Planning & Zoning
Commission
Agenda

Site Plan for Mighty 8th Air Force Museum Phase II Expansion.

Re: National Museum of the Mighty 8th Air Force - Phase 2 - Specific Development Plans

Plans entitled National Museum of the Mighty 8th Air Force - Phase 2 - sheets C1-C14, L1, F1, and E1.0 dated 4/18/24.

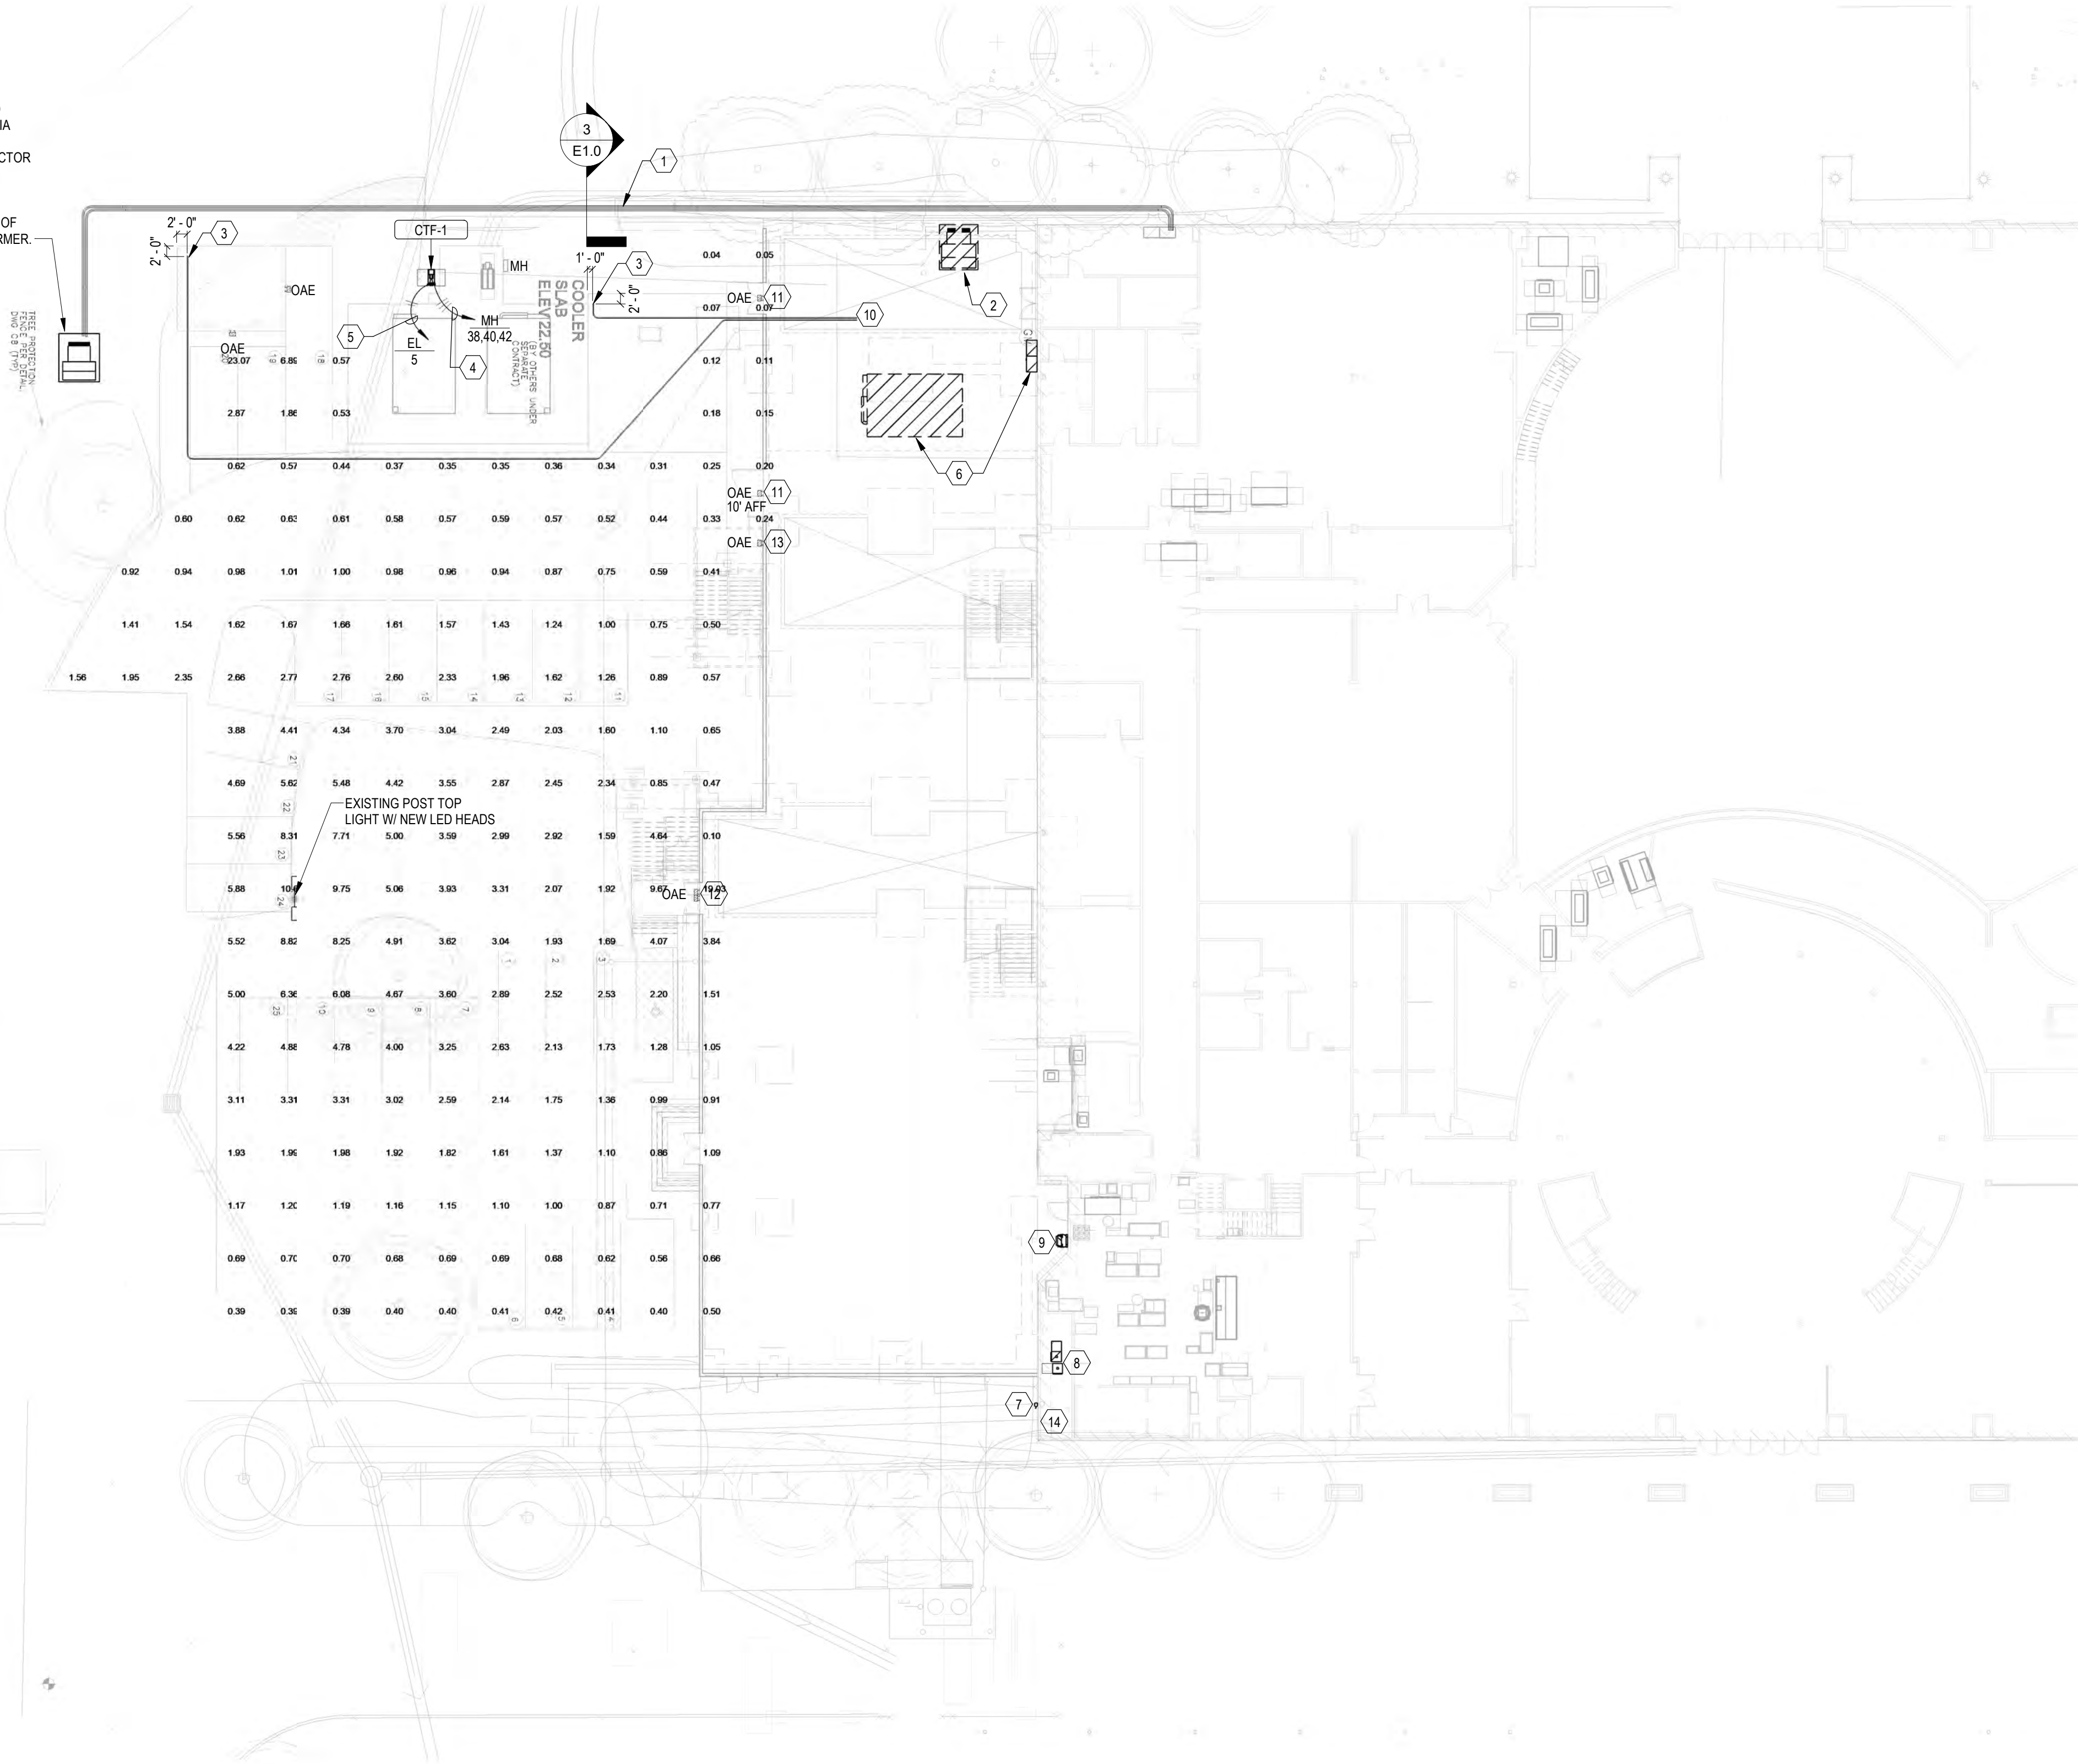
2. Previous Review Comment: Provide on-site lighting plan.
 - a. Coastal Civil Engineering: Lighting sheet has been added to the rear of the plan Set.
 - b. EOM: The provided site lighting plan should demonstrate that the outdoor lighting standards, outlined in the City Code of Ordinances, are achieved. The ordinance specifically states that lighting plans need to not only show the layout of the proposed fixtures, but also iso footcandle plots that demonstrate adequate intensities and uniformity. The Isofootcandle plot is needed to verify that the maintained footcandles, uniformity ratio are satisfactory for the outlined required illumination for the parking lot and pedestrian safety. If you review the outdoor lighting section of the Ordinance, you will find this information and the required foot-candles needed across site. **New photometrics have been included on the revised lighting plan, drawing E1.0.**
